42V00124C

State of Ohio Environmental Protection Agency

September 2, 2010

NPDES Inspection Report

Figure 2.

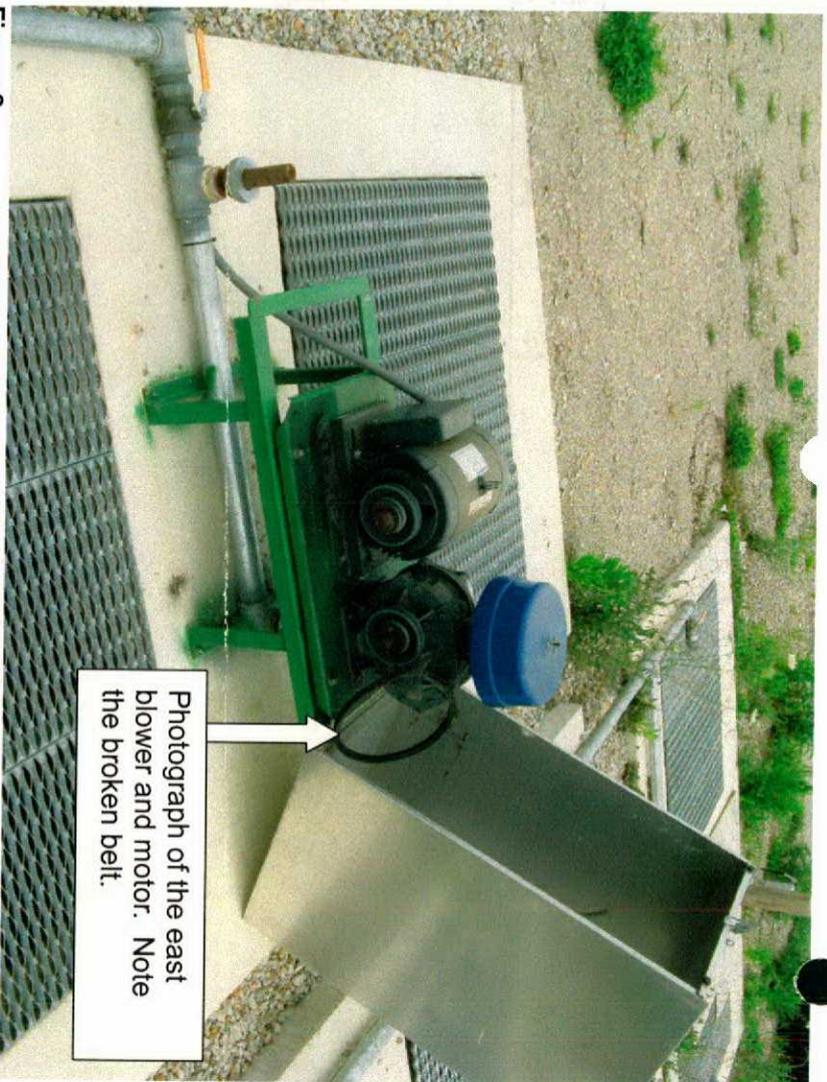
<u>S</u>	Permit
<u>N/U</u>	Records/Reports – discharge monitoring reports are not being submitted.
<u>U</u>	Operations & Maintenance - both blower motors belts had broken thus severely limiting the plant's treatment capability. At the time of this inspection the east blower motor was operating but, due to the broken belt, was not providing power to the blower. An e-mail was sent to Mr. Croston on 8/12/10 asking for the name of the WWTP operator and asking that the belts be replaced immediately. There has been no response to that e-mail.
<u>U</u>	Facility Site Review - wastewater treatment plant (WWTP) installation appeared complete.
<u>N</u>	Collection System
<u>N</u>	Flow Measurement
<u>N</u>	Laboratory
<u>N/N</u>	Effluent/Receiving Waters
<u>N/N</u>	Sludge Storage/Disposal
<u>N</u>	Pretreatment
<u>U</u>	Compliance Schedules – rated unsatisfactory since there have been no status reports submitted to this office as required in the permit compliance schedule. Item 2 in the schedule requires written verification within 14 days of milestone completion.

Photograph of the east blower and motor. Note the broken belt.

Figure 3.

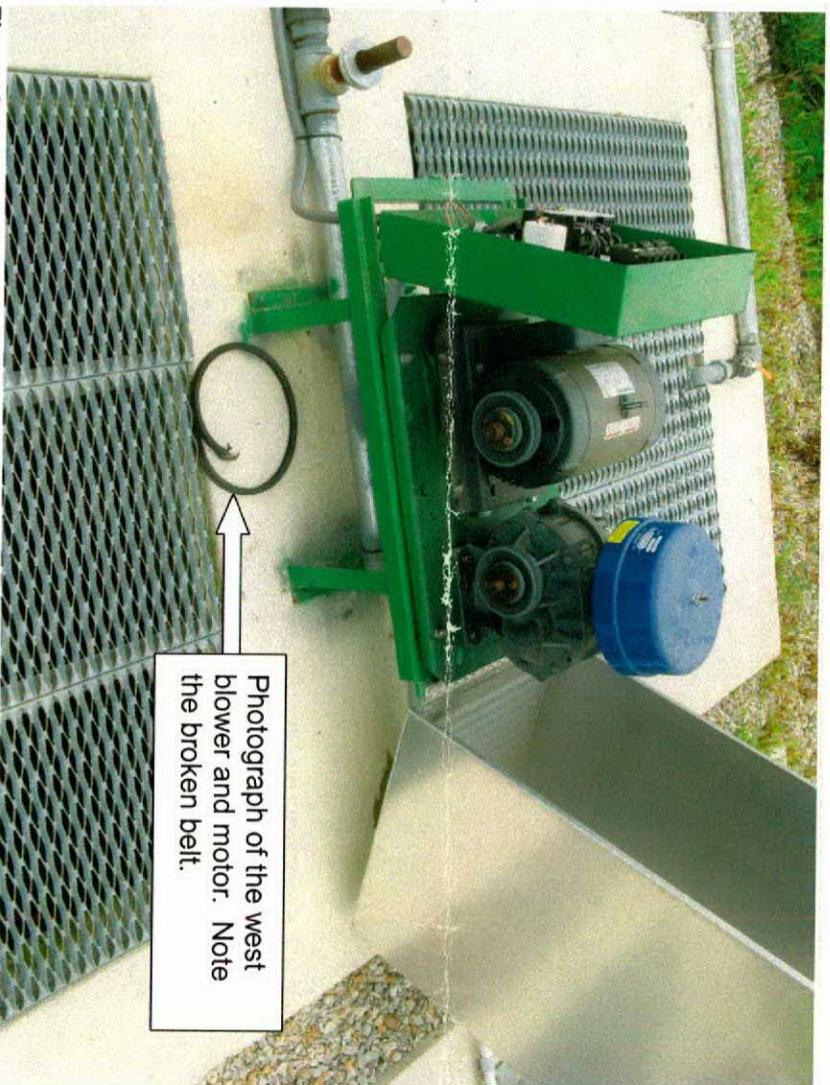
Photograph of the west blower and motor. Note the broken belt.
